East Anglia ONE North and East Anglia TWO Offshore Windfarms

Applicant's Comments on Relevant Representations Volume 3 Technical Stakeholders

Applicant: East Anglia ONE North Limited
Document Reference: ExA.RR3.D0.V1
SPR Reference: EA1N_EA2-DWF-ENV-REP-IBR-000971

Date: 11th June 2020
Revision: Version 1
Author: Royal HaskoningDHV

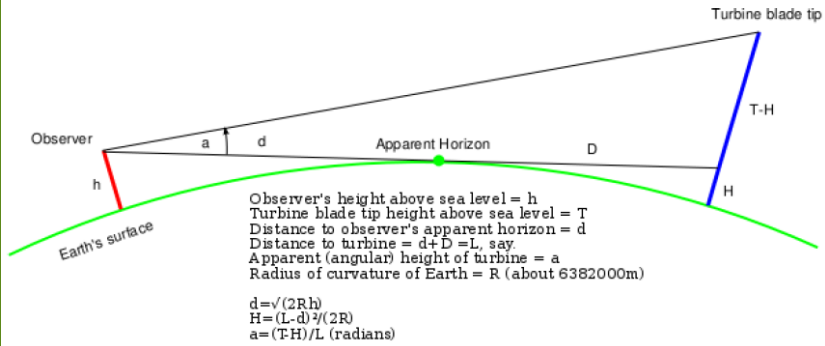
Point Taken from Natural England's Relevant and Written Representations		Applicant's Comments
EA1N Appendix E – SLVIA – offshore elements of the project		
Section 2 – Note about visible height of offshore wind turbines in respect of East Anglia ONE North		
NE-2.1	In our response to the PEIR for the s42 consultation (March 2019) we included the following Natural England observations on the increase in turbine size which has taken place over the past 15 years and the proximity of these structures to the coastlines of designated landscapes, entitled 'Turbine height and proximity to the coastline of a designated landscape' <i>'...The last 10 years has witnessed a significant upscaling of the technology used in the offshore wind farms. Within this time turbines have dramatically increased both in output capacity and size from the 3.6MW machines of 132m height (Sheringham Shoal, Norfolk Coast AONB, closest point 17km) to 6.3MW machines of 181m height (Galloper, Suffolk Coast and Heaths AONB; closest point 29.3km) to the emerging industry 'standard' of 15MW machines of 300m height as proposed for EA2 (closest point 29.6km); capacity has increased nearly fourfold and size more than doubled. When viewed from the same location, the bigger the structure the greater it's visual prominence. Similarly the bigger the structure the greater the distance (and geographic spread) from which it can be seen. In defining our comments to this scheme Natural England has been mindful of these facts and where appropriate has drawn comparisons between previously consented schemes located in the seascape setting of a designated landscape and EA2 to illustrate the likely influence of this upscaling in technology...'</i>	NE's observations are noted by the Applicant, however they appear to relate to East Anglia TWO. The Applicant's response to this point for East Anglia TWO is provided in Section 2.5.2 above, point NE-2.1.

NE-2.2	Since providing these comments we have undertaken further sites visits and analysis to illustrate this point further. The information and evidence gathered is presented below. We have done so in order to provide some evidence which compares the effect of existing offshore arrays, noting that	NE's further information and analysis are noted by the Applicant. The Applicant notes some limitations in this evidence, which is explored further against each point as follows.

Figure 2 Comparative Height of Turbines

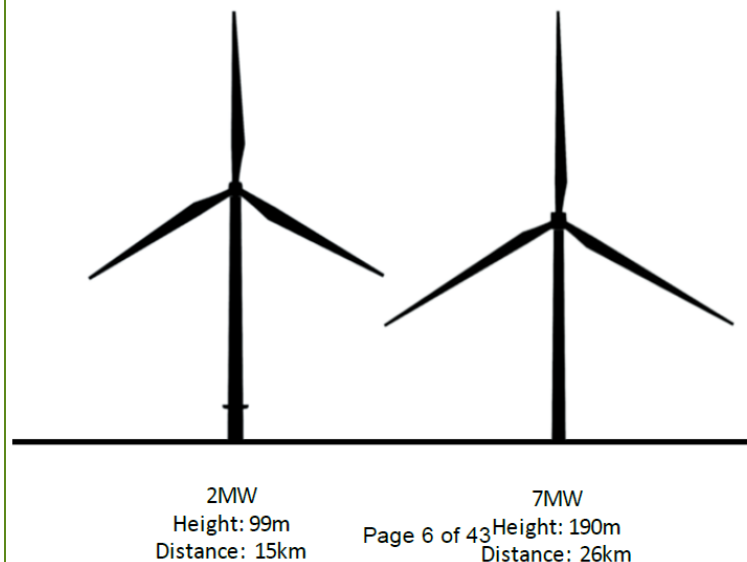
Point Taken from Natural England's Relevant and Written Representations EA1N Appendix E – SLVIA – offshore elements of the project Applicant's Comments

observer. Therefore, it is possible to compare the apparent height of a 134m turbine located at 25km away to that of a 182m turbine located at 29km. This in turn can be used to predict the apparent height of (the not yet built) 300m turbines at 40.1km, as used in the EA1N worst case scenario. As the effects of the former are known, their visual influence can be used to judge the likely effect of the latter when viewed from similar elevations.

While the comparison of turbine height in Figure 2 (left), is useful as a diagrammatic illustration, it is not representative of the scale of the turbines when viewed from coastal viewpoints of the study area; nor representative of the true relationship of the Project with the existing offshore turbines at Galloper and Greater Gabbard, which are not

Point Taken from Natural England's Relevant and Written Representations		Applicant's Comments
EA1N Appendix E – SLVIA – offshore elements of the project		
		viewed directly next to each other in the way presented in Figure 2. The apparent scale differences will not, in reality, be viewed in this very direct way presented in Figure 2, as there is physical separation between layouts on the horizon, which means that the scale comparisons will be more subtle than indicated in this image. The scale of the Project turbines is best appreciated at the viewpoints with reference to the photomontages included in the SLVIA (Figures 28.25 – 28.54 (APP-355 to APP-380)). If viewed correctly at the correct printed image size, these provide a close representation of the vertical scale of turbines in actual viewpoints. The Applicant considers that the wireline visualisations presented in the SLVIA (Figures 28.25 - 28.54 (APP-355 to APP-380)) are the best tool to understand the scale relationship with other offshore wind turbines. There is also the factor that increased distance inevitably results in some lessening of the turbine visibility from the shore due to atmospheric conditions, so they are not directly comparable in terms of their relative magnitude of change, only relative height.

Figure 3: Height Comparison

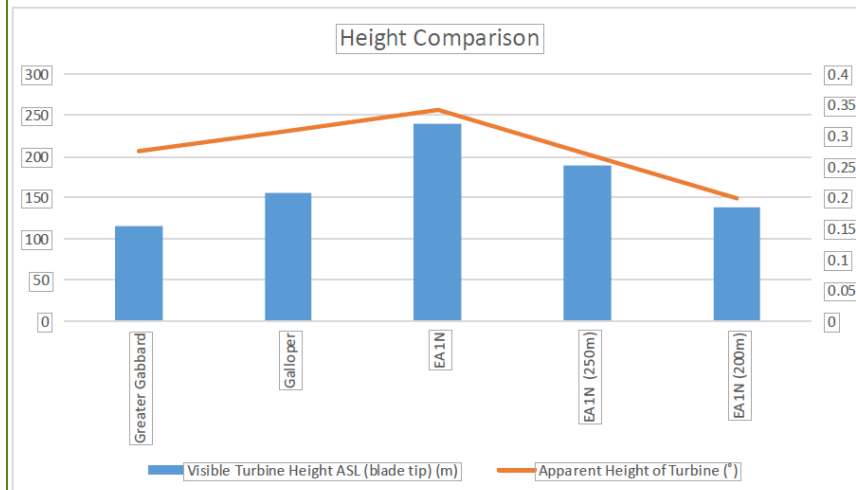
Also listed are calculations for 250m turbines located at 40.1km offshore in order to show the predicted visible and apparent heights for such turbines.

While the tabular analysis of apparent height may be a useful tool for comparing the apparent height of turbines from the closest point of the coast to each offshore windfarm, the Applicant notes that there are limitations in the analysis presented.
